**AMENDMENT NO. 2 NOVEMBER 2011
TO
IS 13049 : 1991 DIAPHRAGM TYPE (PLASTIC BODY)
FLOAT OPERATED VALVES FOR COLD WATER
SERVICES — SPECIFICATION**

(*Page 6, Annex E*) — Substitute following for the existing:

All dimensions in millimetres.
FIG. 4 FLOW TEST APPARATUS

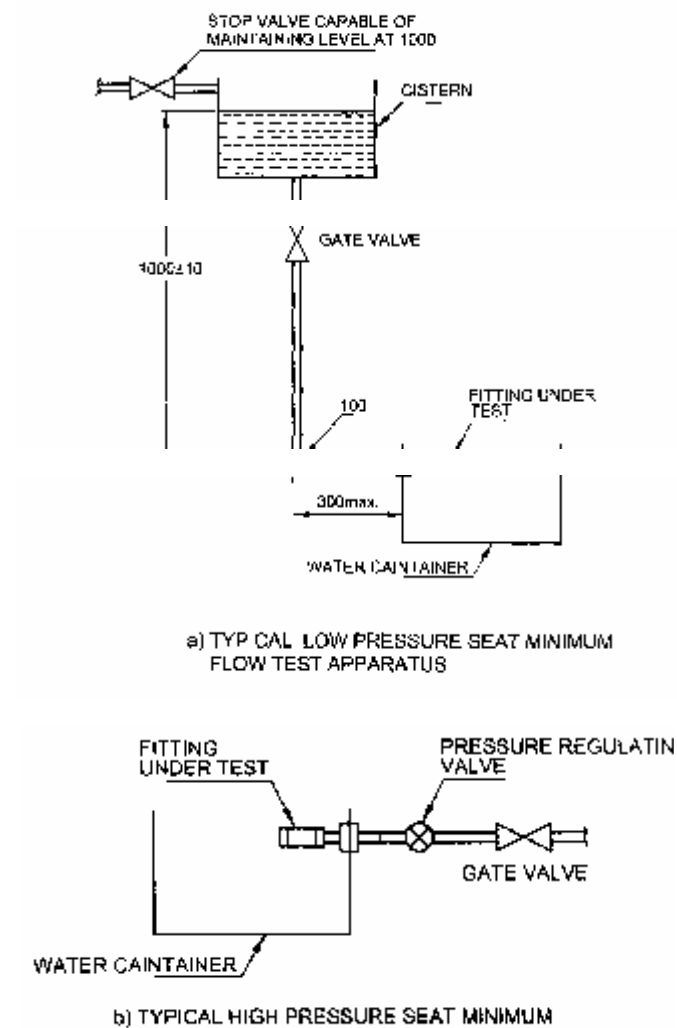
E-1.1.1 A test rig [*see Fig. 4(a)*] capable of maintaining 1 ± 0.1 m head of water at the seat of the valve under test, comprising a cistern, connected through 15 mm copper pipe work to the specimen valve via a controlling gate valve.

Fit the float operated valve (installed with the LP seat) to be tested together with its discharge arrangement. Remove the float. Cause the valve to discharge water from cistern *A* into container *B* [*see Fig. 4(a)*] for a period of 140 ± 5 s whilst maintaining, for the duration of the test the water level in cistern *A* at a height of 1 ± 0.1 m above the centre of the inlet of the valve.

E-2.1.1 A test rig [*see Fig. 4(b)*] capable of maintaining a constant pressure of 0.35 ± 0.01 MPa the inlet of the valve under test, connected through 15 mm copper pipe work to the specimen valve via a controlling gate valve.
